WARRANTY BULLETIN

WB13-48A

DATE :	AUGUST 2013	SECTION :	07 - Transmission
EXPIRATION:	AUGUST 2015		
SUBJECT :	RETARDER COOLER PIPING SUPPORT - WELD INSPECTION AND REPLACEMENT

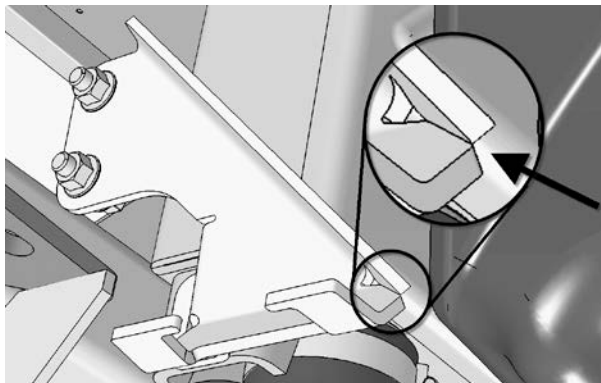
2. Using a telescopic inspection mirror, Make sure there is a weld fillet at this location on the piping support.

If there is a weld present, no further action is required.

View from bottom

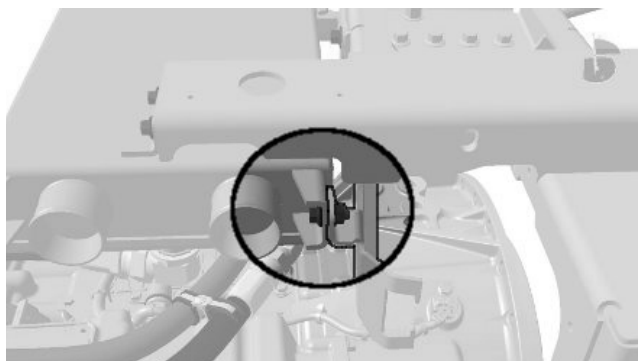
If there is no weld, the part should be replaced.

1. Close the heating valves and make sure vehicle has cooled down for next steps.
2. Empty the coolant in an appropriate container.
3. Create some working space by removing the piping clamps, inlet and outlet piping and elbows. Collect any coolant left at this point.

This should give you access to the support bolts.

Reverse angle.

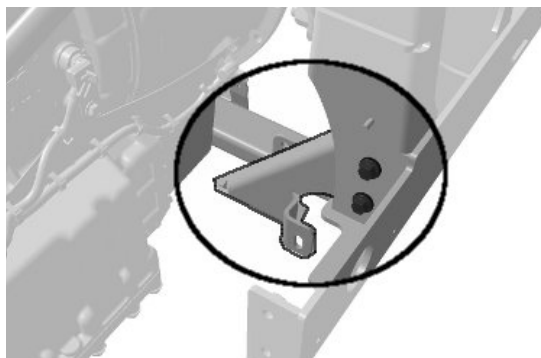
Refer to images for mounting bolt locations

4. Remove and discard the piping support and replace with the new part.
Tighten to 32 lbf-ft (44 N-m)
5. Re-install the piping and elbows.
6. Fill the coolant system.
7. Re-open heating valves.
8. Check cooling system for leaks and vehicle for proper operation.
